CS North-South Cycle Route (Phase 2)

Concept Design (Rev 2A.1)

Stage 1 Road Safety Audit

Ref: 2462/VAR/A201/TLRN/2016

Problem Locations

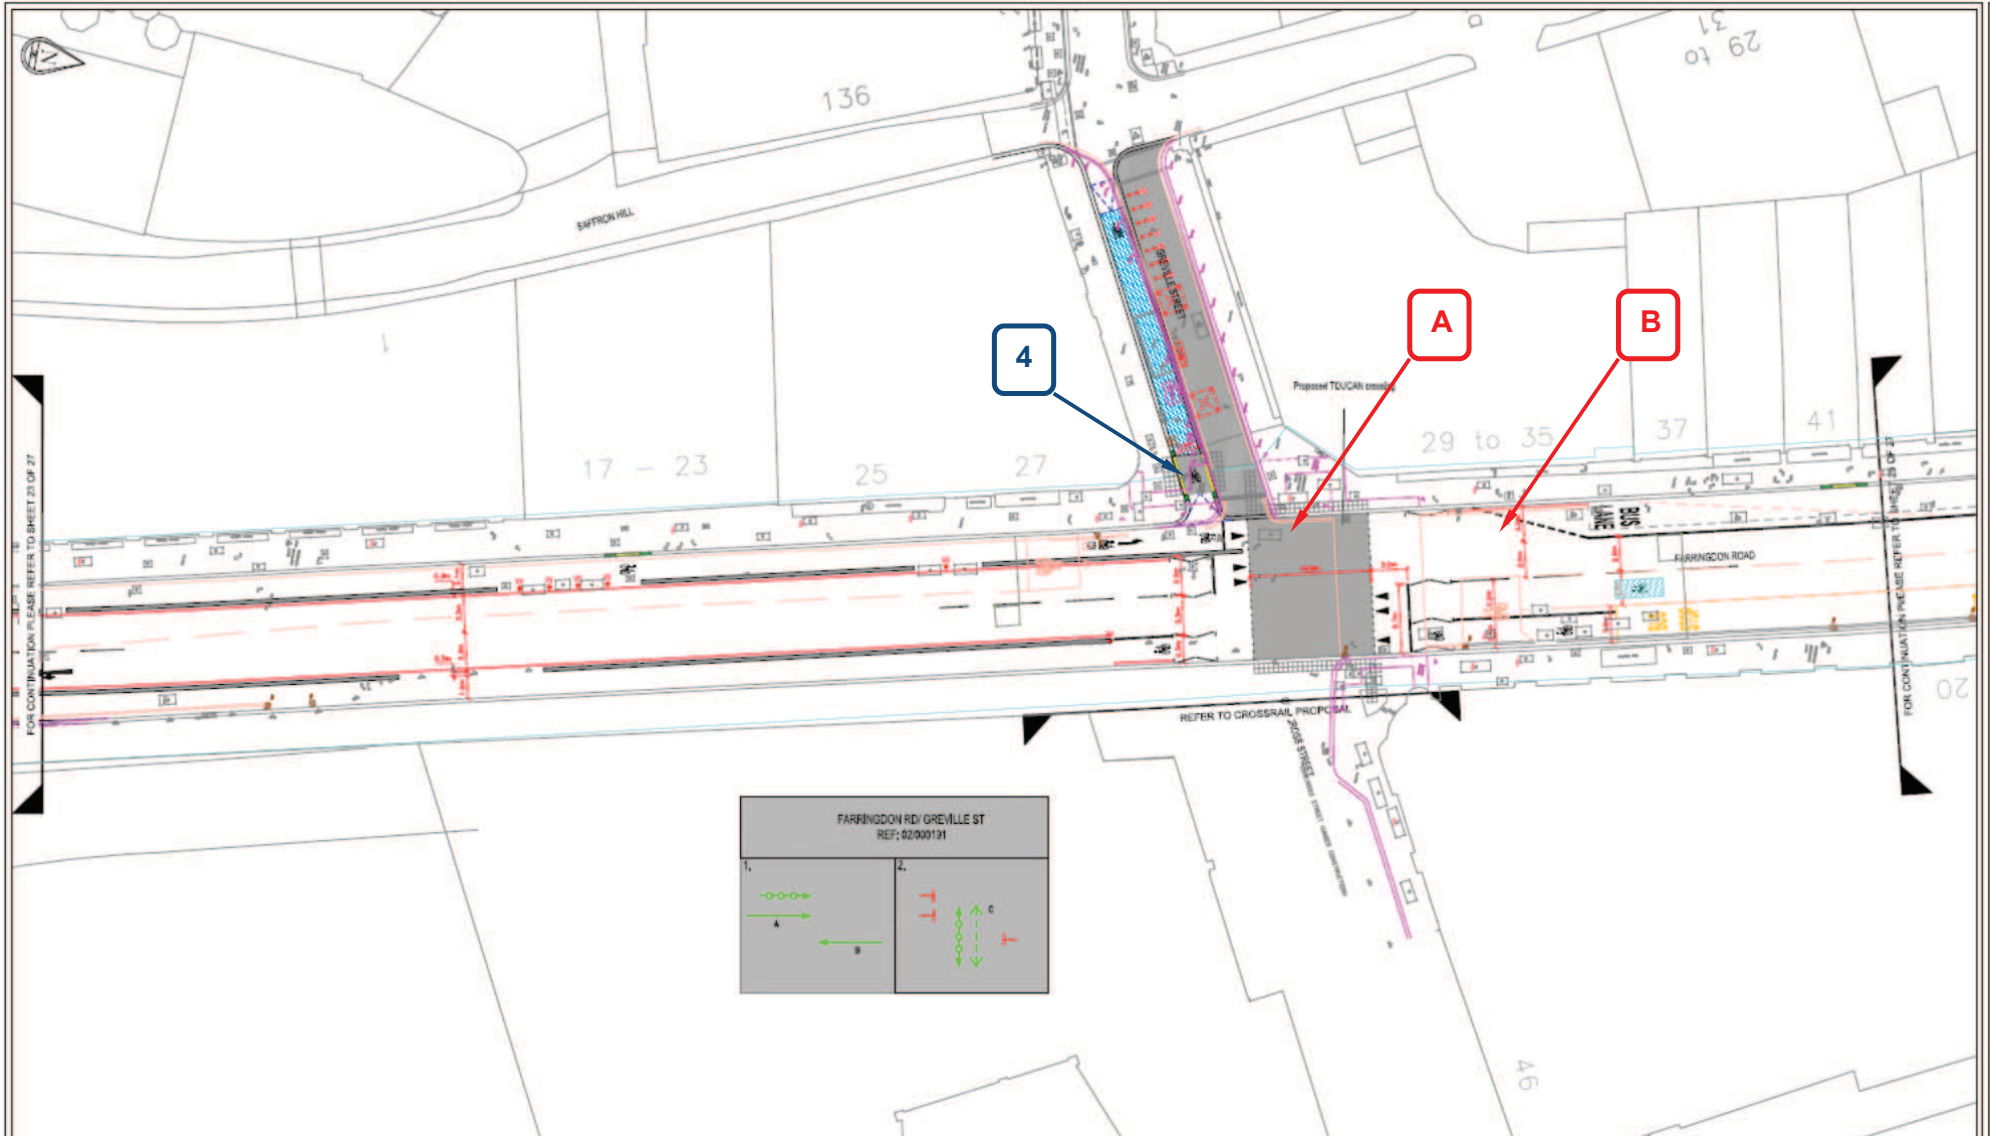
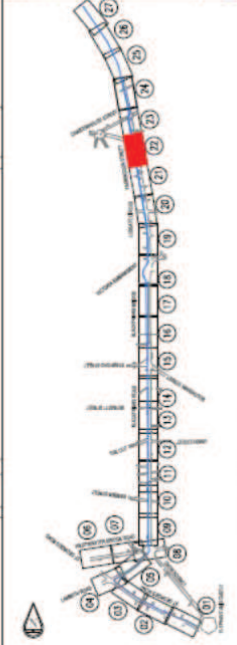
Location: A – Farringdon Road junction with Greville Street

Summary: Alignment of segregated facility may promote non-compliance with the pedestrian crossing facility

The Audit Team is concerned that the alignment of the segregated facility at the junction with Greville Street may encourage cyclists to ignore or fail to appreciate the pedestrian crossing facilities. The layout through the crossing facility is at a similar level and a straight alignment, therefore no measures are provided to encourage cyclists to curtail their speed and stop when required. Hence cyclists may fail to appreciate the necessity to stop at these locations either accidentally or deliberately. A potential for conflict with pedestrians may exist as a result.

Location: B – Farringdon Road junction with Greville Street

Summary: Alignment of segregated facility may exacerbate a potential for conflict with other road users on the exit from the segregated facility

The Audit Team is concerned that the alignment of the carriageway at the exit from the segregated cycle facility may exacerbate a potential for conflict with cyclists. As soon as the cycle segregation terminates, buses and other road users are likely to try and enter the bus lane. Drivers performing this manoeuvre may be unaware of the presence of cyclists approaching on the nearside, particularly when congested and the approach speed of cyclists exceeds that of the general traffic lane. An exacerbated potential for cyclists to be squeezed against the kerb, with an associated potential for injury may exist as a result.

Location: C – Farringdon Road outside number 20

Summary: Cycle lane and bus stop layout may pose a hazard to cyclists

The Audit Team is concerned that the alignment of the carriageway at the exit from the cycle segregation requires cyclists to transition around buses over a very short distance. As soon as the cycle segregation terminates, buses are likely to try and access the bus stop. Drivers performing this manoeuvre may be unaware of the presence of cyclists approaching on the nearside, particularly when congested and the approach speed of cyclists exceeds that of the general traffic lane. An exacerbated potential for cyclists to be squeezed against the kerb, with an associated potential for injury may exist as a result.

Location: D – Farringdon Street opposite West Smithfield

Summary: Loading bay location may hamper visibility for pedestrians and cyclists

The Audit Team is concerned that the proposed loading / disabled bay may restrict visibility to / from pedestrians and cyclists. The pedestrian and cycle facilities are located immediately downstream of the bay, hence any vehicle located within the bay is likely to impact on the forward visibility from these facilities. Pedestrians and cyclists may fail to appreciate when it is safe to proceed due to the reduced visibility, entering the carriageway injudiciously. Pedestrians and cyclists entering the carriageway injudiciously may be at a exacerbated potential for conflict with vehicles.

Location: E – Farringdon Street approach to West Smithfield

Summary: Carriageway alignment may pose a hazard to road users

The Audit Team is concerned that the southbound carriageway in proximity to the bus stop guides road users into the central pedestrian refuge island. Should a bus be located within the bus stop, road users passing the bus may fail to appreciate the abrupt requirement to deviate around the pedestrian island. An exacerbated potential for conflict with the feature, with associated potential for personal injury may exist as a result.

Accepted: The proposals omitted the zig-zag markings in the northbound cycle track. This is a drafting error and has been corrected. The signalised crossing now includes all the standard features. (See Rev2A.2 drawings)

The pedestrian crossing at Greville St is a signalised crossing with associated stopline and signal head visible to northbound cyclists. The proposal also shows that the pedestrian crossing area is raised to footway level to highlight the crossing and improve the pedestrian level of service. A ramp road marking (diag 1062) helps to reinforce this. The pedestrian crossing area will also be surface dressed in a buff colour.

Part Accepted: Continuing the physical protection for cyclists is not recommended because there is only space for a short and narrow length of segregation which may encourage pedestrians waiting at the crossing to cross part-way (the cycle track) and seek refuge in a narrow strip of segregation (300m). This could put those choosing to wait at the island in a vulnerable position with no clearance from the narrow traffic lane.

Accepted: The current proposals include a 12m mandatory cycle lane before the 36m bus cage begins. The designs have been altered so that the mandatory cycle lane is now 23m long and the bus cage is 25m long so that there is a longer length of re-integration space.

Design Organisation Response	Accepted
<p>Accepted: An overrunable area adjacent to the loading bay and pedestrian crossing refuge has been incorporated in the design. This encourages northbound vehicles to align themselves with the centre of the carriageway as opposed to the nearside. Through use of this area, visibility is improved for cyclists and pedestrians wishing to cross the carriageway as they can see around any vehicle in the bay. (See Rev2A.2 drawings)</p>

Accepted: Keep left bollards are proposed on the pedestrian refuge island to maximise its visibility with diag1004 hazard markings guiding them around the island (See Rev2A.2 drawings). The informal crossing is on a desire line and cannot be relocated owing to the right turn pocket to the south and the bus stop to the north. The refuge is of benefit to the crossing pedestrians and removing it would create a greater collision risk in comparison.
